PLANNING COMMISSION STAFF REPORT

OAKRIDGE SUBDIVISION – DESIGN PLAN

Re: Oakridge – Design Plan Review

SITE PLAN
OAKRIDGE SUBDIVISION
MILITARY SURVEY #710
GOSHEN TOWNSHIP
CLERMONT COUNTY, OHIO

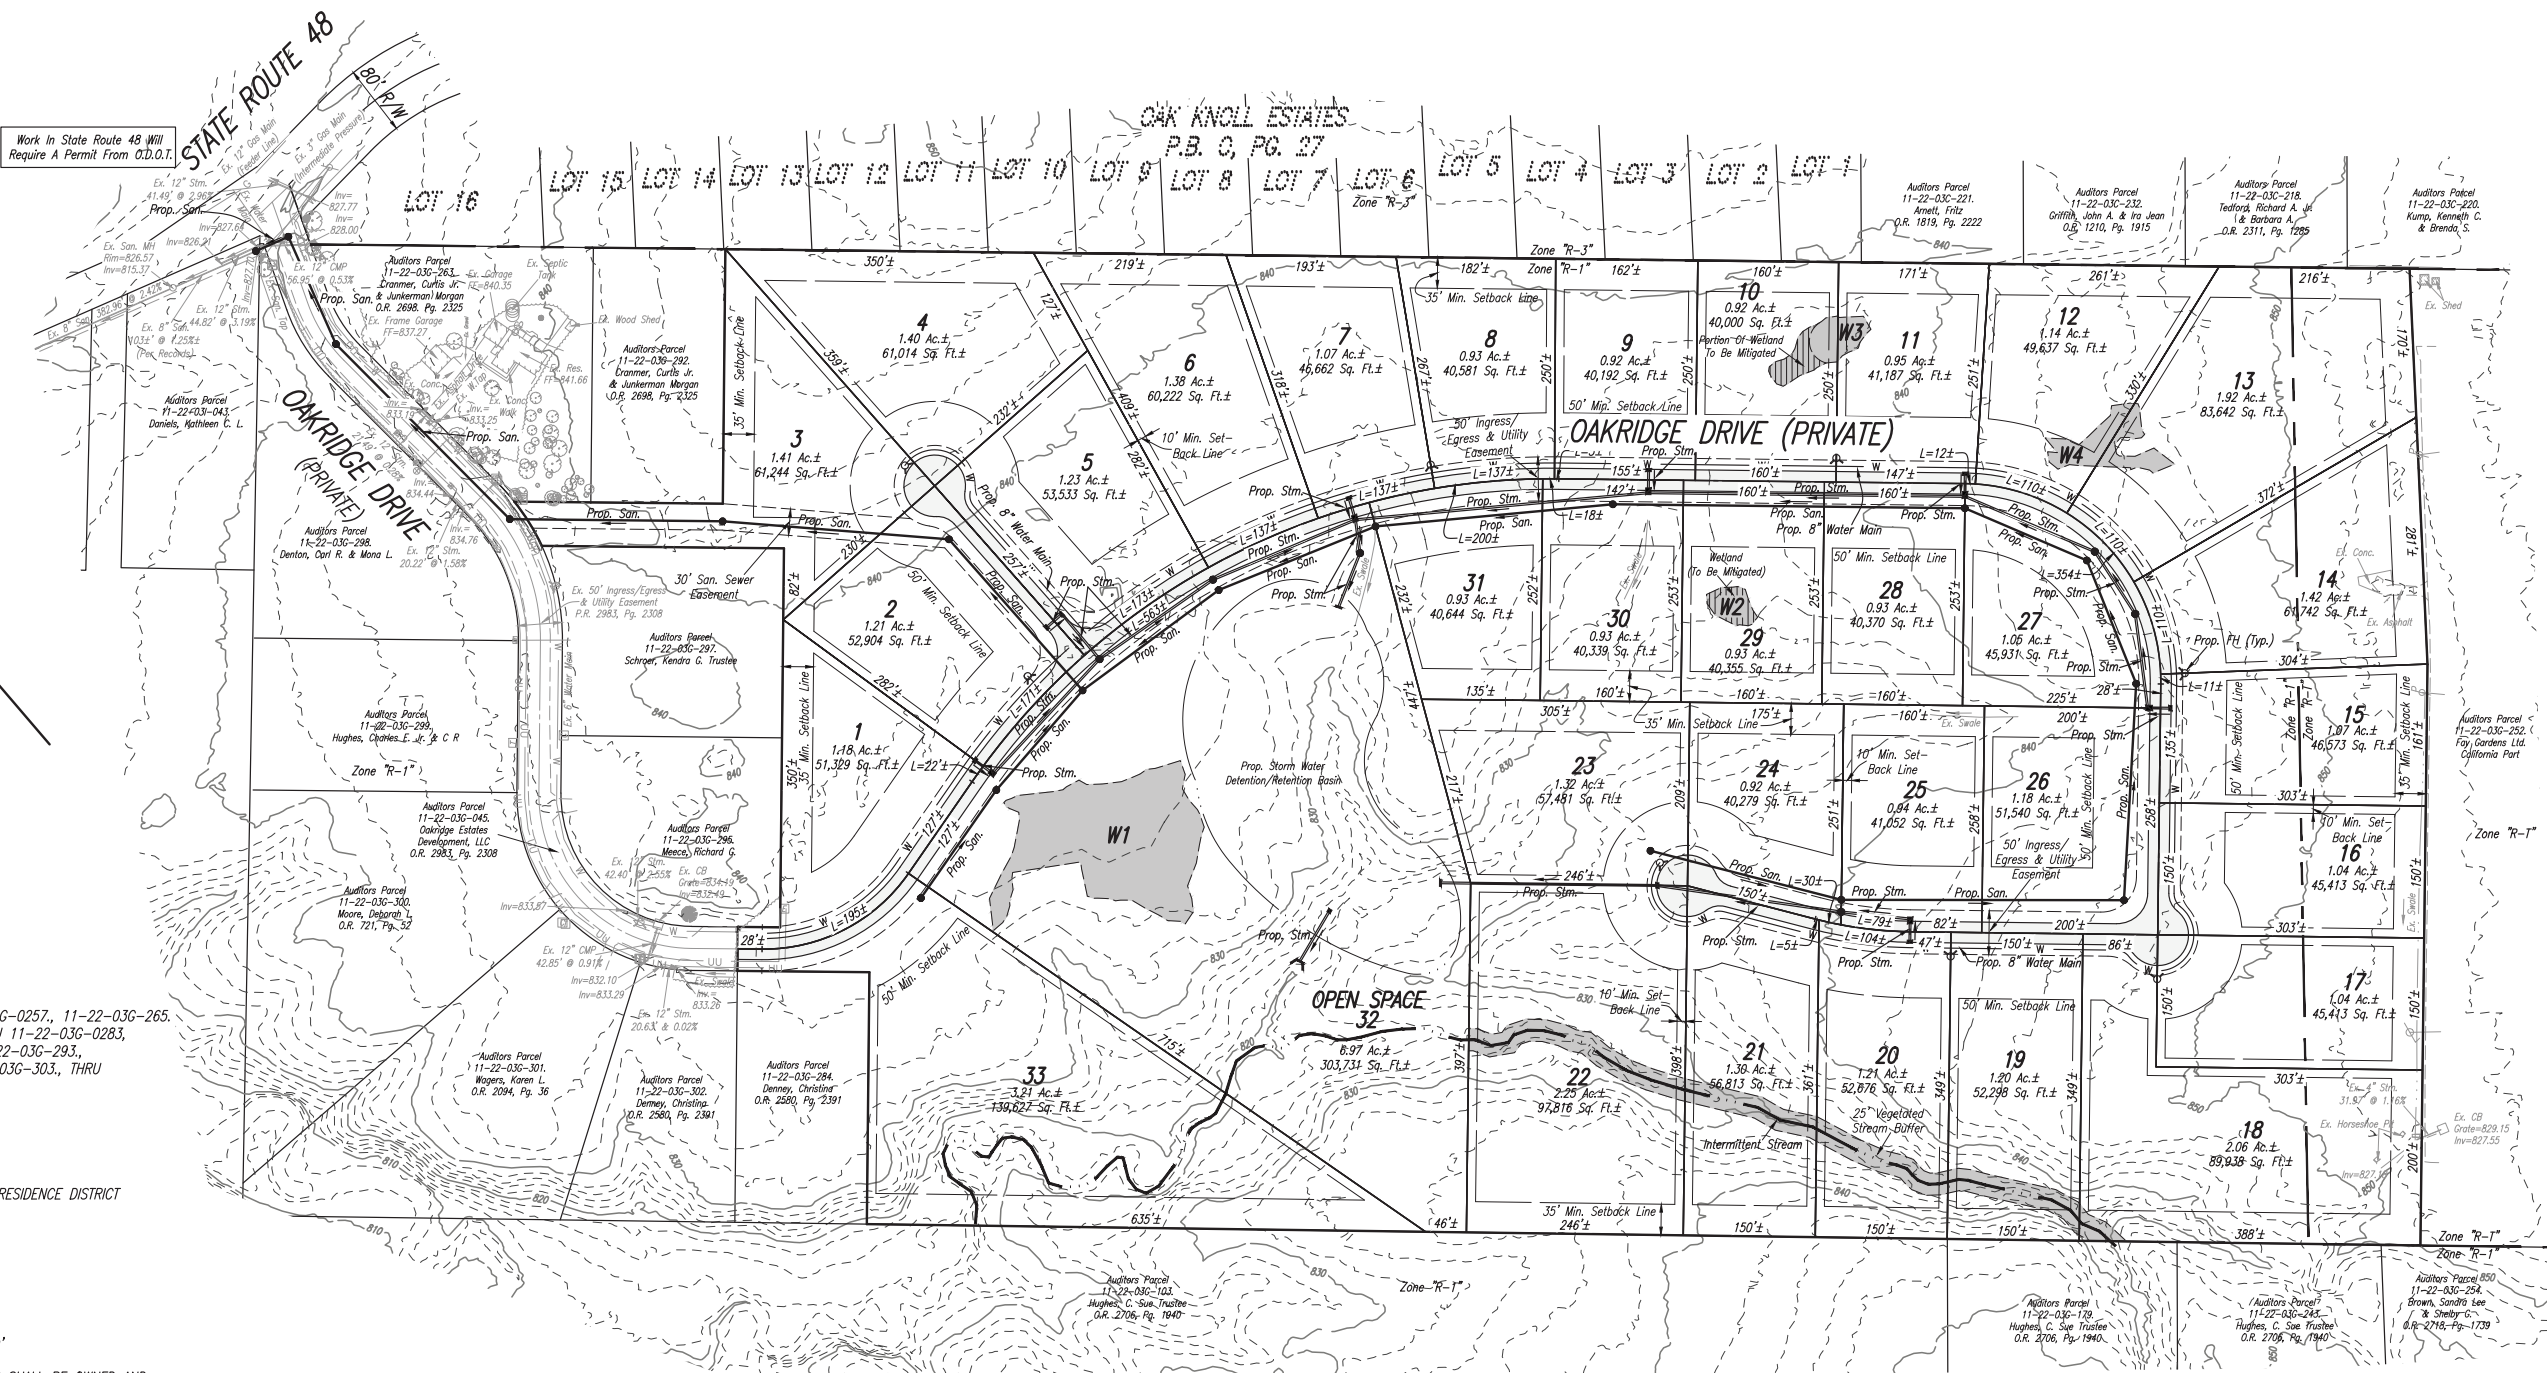
1. Ohio Department of Transportation needs to approve the submitted plans, along with the proposed utility work adjacent to State Route 48.
2. Oakridge Drive needs to be labeled as a Private Street.
3. A minimum forty foot (40') Private Street Easement needs to be provided for Oakridge Drive.

1. Show fire hydrant easements according to CCWRD standards.
2. Water main should be inside of appropriate easements of 30 ft (10'/20').
3. Detail water main with valve type, location, size, and all appropriate labels and details.

4. Show sanitary sewer easements for the proposed sanitary sewer which has a 30 ft (10'/20') easement.
5. Include a callout for the Sanitary Sewer size like how the proposed water main is called out.

6. Callout the sanitary sewer manholes, include appropriate information on manholes.
7. Include Elevation views of the sanitary sewer and water main.
8. Show proposed sanitary sewer laterals, cleanouts at right-of-way, water services, water meter locations.

- a. Make sure cleanouts and water meter locations are in green spaces and not in driveways or sidewalks.
9. Show all appropriate CCWRD details, drawings, notes and other applicable regulations.

10. Please confirm that the storm sewer drains are more than 10 feet from the water main or file for write this in your variance on the PTI to the EPA.

1. Please provide the Wetland Report approval from the OEPA.
2. Confirm whether the proposed stormwater detention/retention basin is part of an existing stream or if natural drainage flow is directed through the proposed basin location.
3. Lots #19-22 contain a designated intermittent stream. Please clarify how development will be proposed on these lots. If the stream is to be relocated, provide suggested building locations for its final placement.
4. If the stream is relocated, submit a copy of the Section 404 permit from the U.S. Army Corps of Engineers, along with stormwater calculations demonstrating compliance with WMSC requirements.
5. Establish a private drainage easement for the stream and provide Minimum Opening Elevations (MOEs) for all lots affected by a 100-year storm event.

1. Wetland comments:
 - a. Wetland delineations need to be conducted if not done so already
 - b. A jurisdictional determination is needed from the U.S. Army Corps of Engineers, as well as a 404 permit for any jurisdictional wetlands that will be disturbed.

- c. A 401 Water Quality Certification is needed from Ohio EPA
 - d. Assuming wetlands 2-4 are not left in a natural state and not placed in a conservation easement, the entirety of these wetlands should be considered disturbed, possibly requiring mitigation

2. A note is needed stating that the HOA will have long-term responsibility for all storm sewer infrastructure (not just the basin). Alternatively, a request could be made of the Clermont County Engineer's Office to create a storm water district for the subdivision (recommended).

3. Easements are needed for storm sewers, storm water management basin, the basin's receiving stream, and the intermittent stream through Lots 18-22.
4. A suggestion only: if a retention pond is constructed and the discharged could be diffused, the pond could outlet into wetland #1 for additional treatment.
